March 21, 2018

The Performance Based Operations Aviation Rulemaking Committee (PARC) is pleased to submit the following recommendation, which will update a current design standard requirement and for RNP AR instrument approach procedures. A brief summary is noted below, and the entire recommendation and supporting information is detailed following this letter.

RECOMMENDATION FOR REMOVAL OF 50-SECOND RULE FROM AR

Example – 50 second rule prevents procedure from being implemented – KLGA RW 13

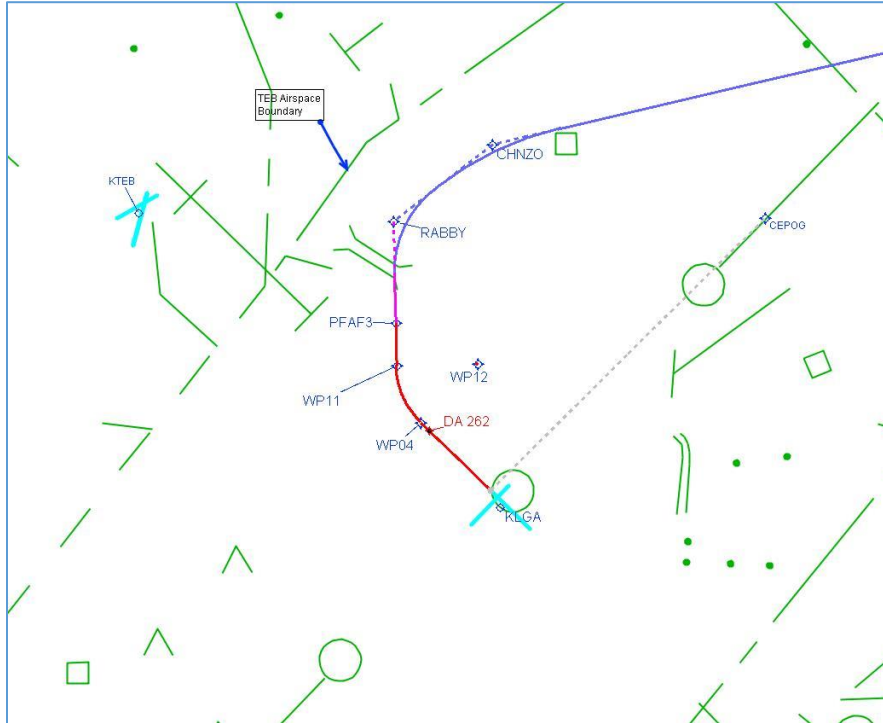
The picture below shows the RNAV (RNP) approach that remains clear of KTEB airspace and overlays the existing RNAV (GPS) approach that meets the requirements for ATC and Environmental approval. The problem lies with the distance from the FROP (WP04) to the DA being less than the required distance to comply with the 15/50 second rule.

In the picture below Targets generated a distance based on both the 15 and 50 second rule. The proposed RNP approach for LGA may be possible using a RNP 1 missed approach segment that will facilitate the use of a 1.40NM FROP segment length. However, if the FAA moves the DA to a higher altitude the 15 second rule will cause the FROP to move away from runway 13 causing an airspace issue that will prevent this approach from being developed. If the DA remains where it is, the 50 seconds prevents development of the procedure. TARGETS clearly shows that 15 seconds will work and the 50 will prevent implementation.

RNAV (RNP) W RWY 28R

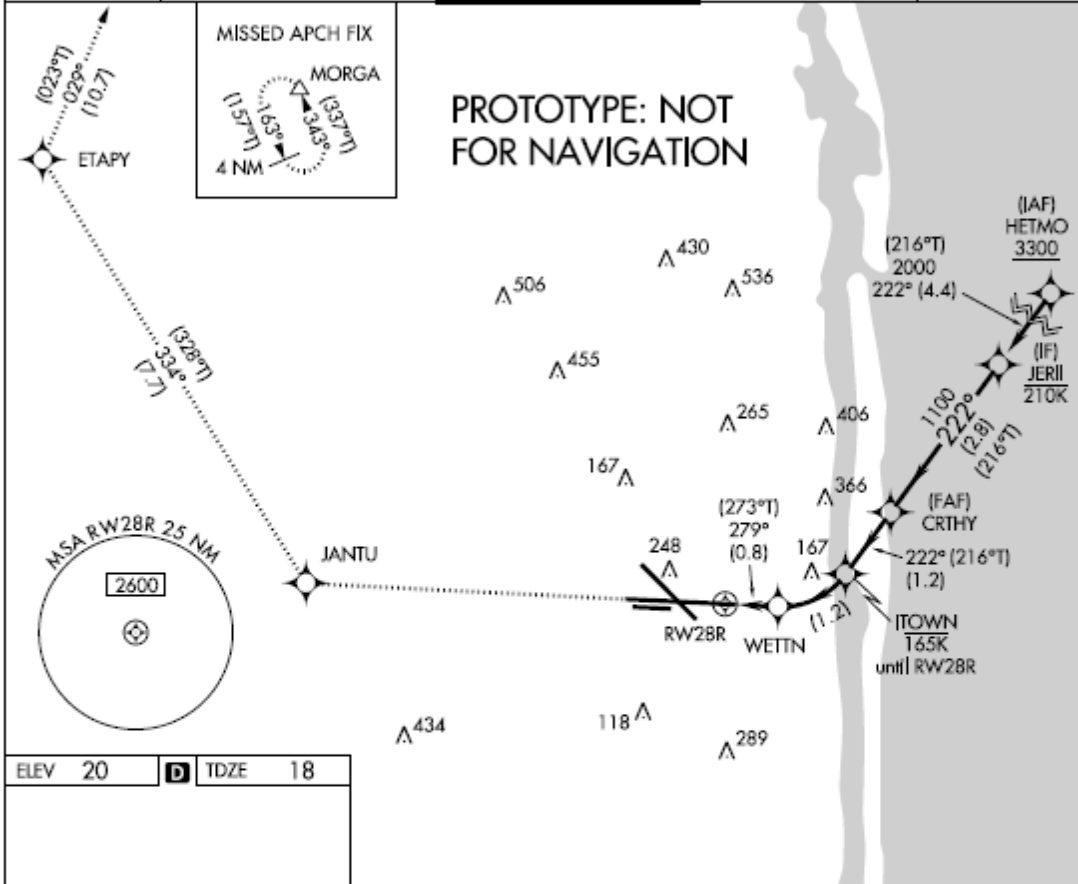
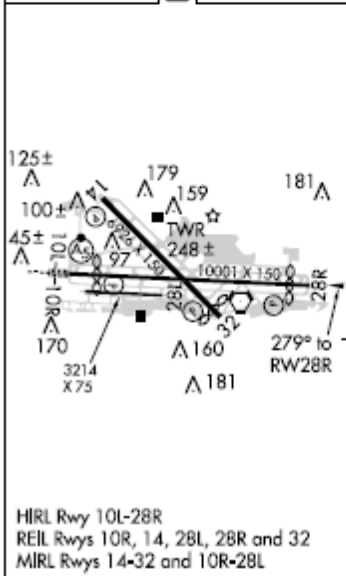
This is our first case of the “no DA in the turn” has caused very high minimums to be placed into a RNP approach. When using the .3 RNP DA, the DA would be in the turn, thus not implementable. However, when using the .1 RNP the DA would be after the turn but not meet the 15 second rule. The solution was to move the DA prior to the turn, a very sub-optimal design for RNP compared to the RNAV procedure. See the two procedures below.

RNAV (GPS) X RWY 28R

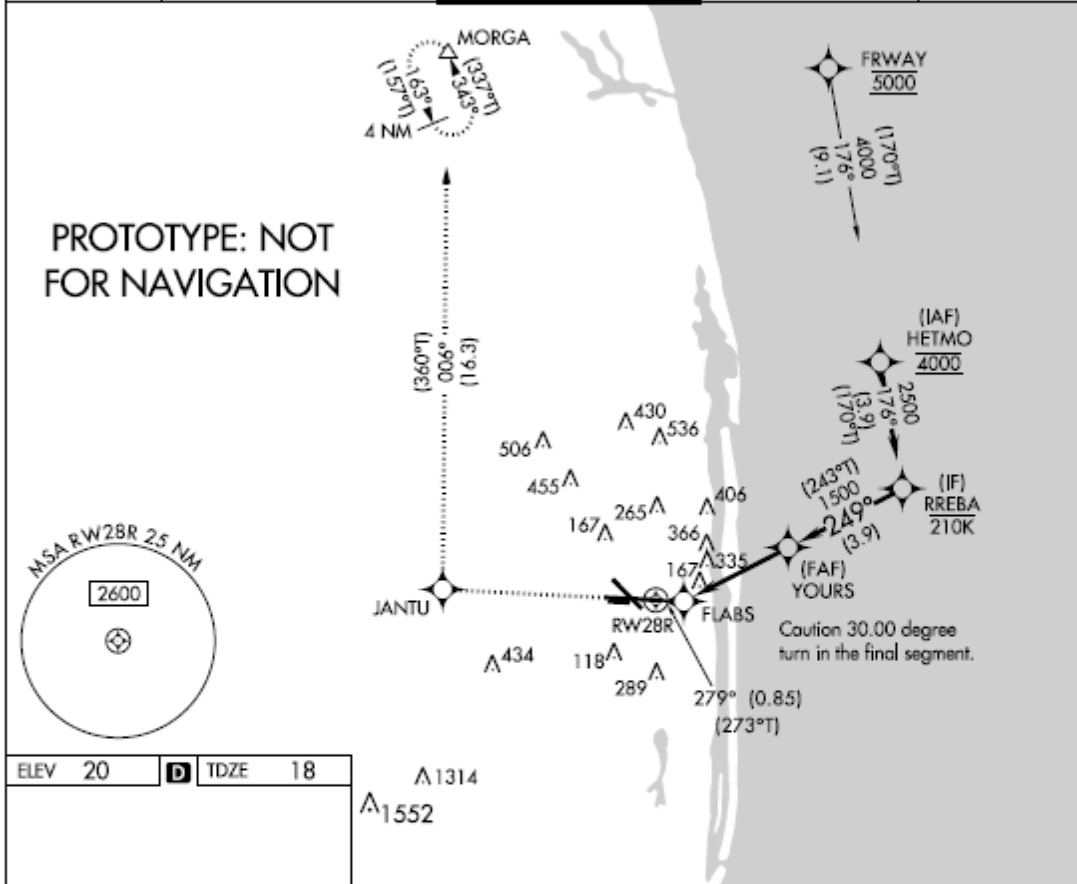
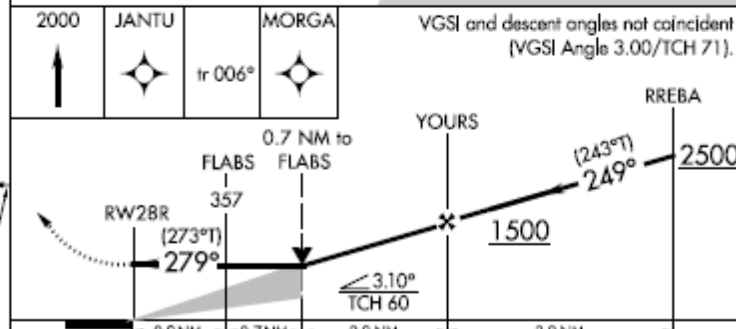
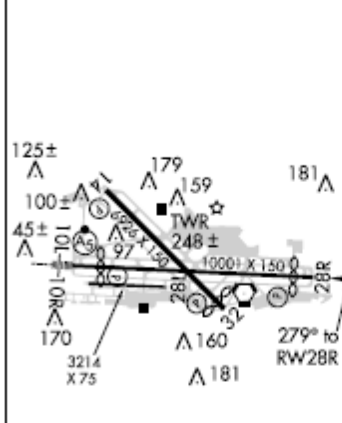
The ironic item is the FAA has designed a GPS approach with lower minimum’s that requires the crew to turn the aircraft after the MDA without vertical guidance.
